NEWMAR CORPORATION

TECHNICAL SERVICE BULLETIN

DATE ISSUED	MODEL YEAR(S) AFFECTED	TSB #
12/27/2017	2017, 2018	498

How to Install an HWH Reset Switch

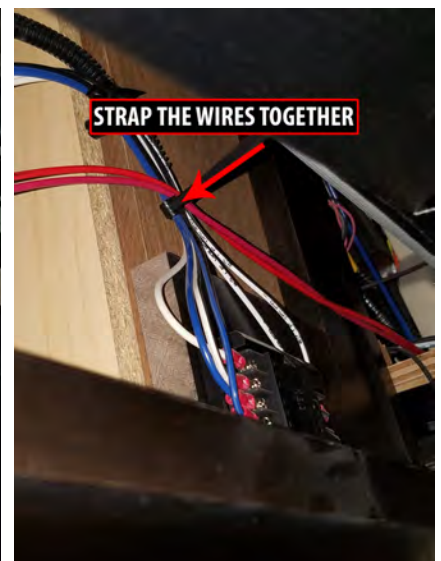
8. Drill a 1 3/8" hole.

9. Install the switch into the panel with two black self-tapping screws.

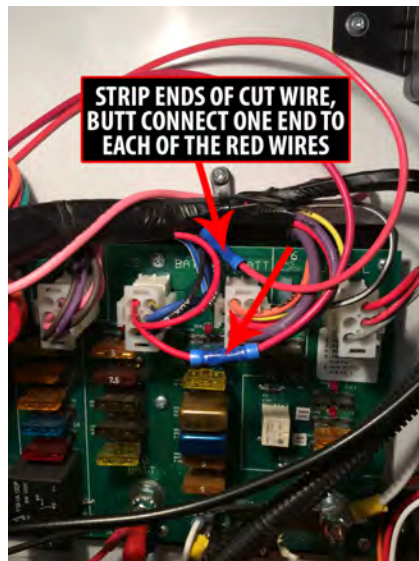
12. Reinstall the A-pillar cover and panel in the front overhead.
13. Install the sticker.
